VEMS v3 genboard checklist before final assembly (srl 9900-10499)

If your VEMS v3 genboard's serial number is 9900-10499 please follow these instructions during assembly. On assembled ECUs normally done when applicable, but check if converting (eg. adding 3rd trigger or mcp3208/ch5 analog input).

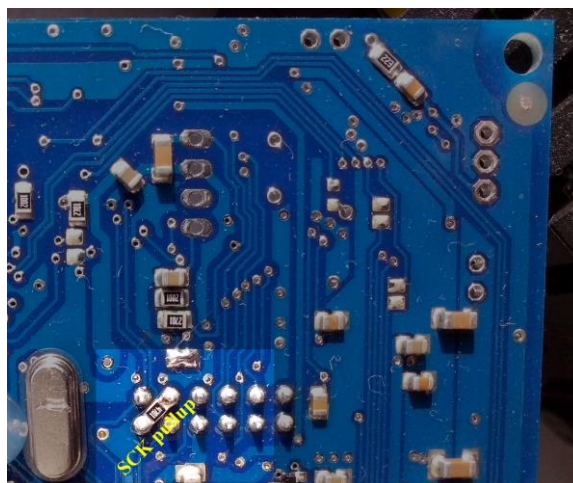
- Check **reset circuit**. Solder the components if not already populated (for lower „reset impedance” and better noise suppression eg. during powerup):

Creset = 220nF (parallel with Ropt)

Ropt = 100k is optional, piggybacked on top of Creset (which is required!)

Ru26 = 10k reset pullup

R53 = 0R (preferred; traditionally 1k)

SCK pullup = 4k7 diagonally on ISP header, bottom side

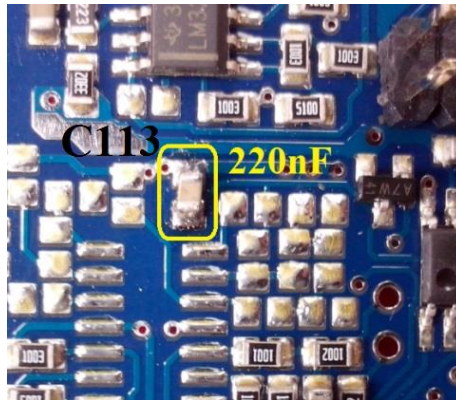
- Check **SCK pullup** required. Solder the components if not already populated. (on ISP header, bottom side)
